Santic (Bangladesh) Co. Ltd.

27 February 2025

Structural Inspection Report

Observation 2: Incomplete lateral stability system of roof shed (Main Building).

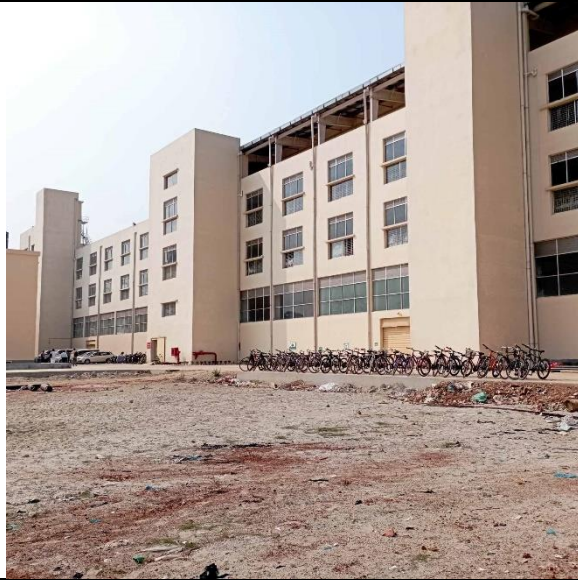
Description: Load transfer media is provided; horizontal bracing is provided on the east side but not on the west side. No vertical bracing is provided to resist the lateral load for the shed part. The building engineer is required to check the lateral stability of the roof shed.

Observation-3: Discrepancy in provided drawing (Main Building).

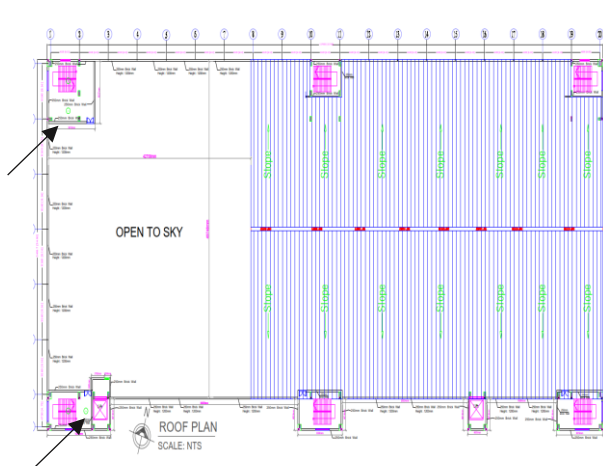
Description: 5 plastic tanks were found (capacity 7500 liters each), but only two tanks were shown in the drawing. The building engineer is required to update the as-built drawing.

Observation-4: Water ponding on roof Slab (Main Building).

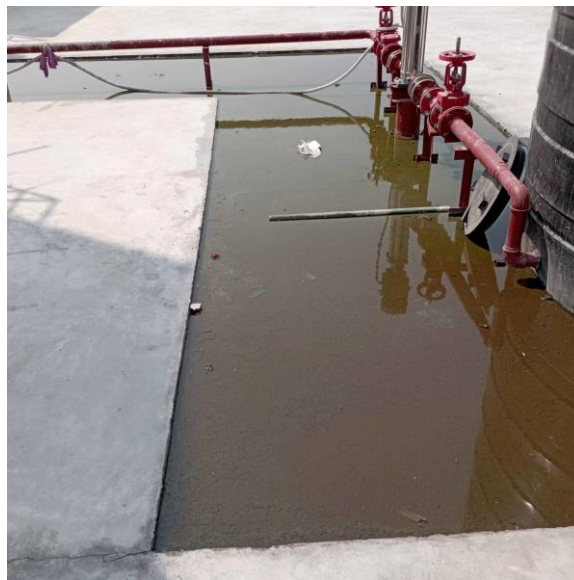
Description: Water ponding on roof slab due to poor drainage system. The building engineer is required to improve the drainage system on the roof slab.

Main Building

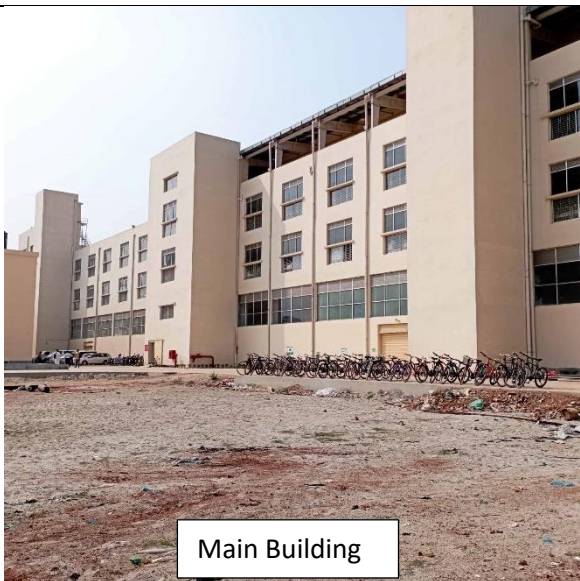
Observation 9: Lack of approval layout/drawing from local authority. (All structures).

Description: No approval layout/drawing was available from the local authority for any of the structures. The factory is required to collect approval layout/drawing from the relevant local authority for all structures within the factory.
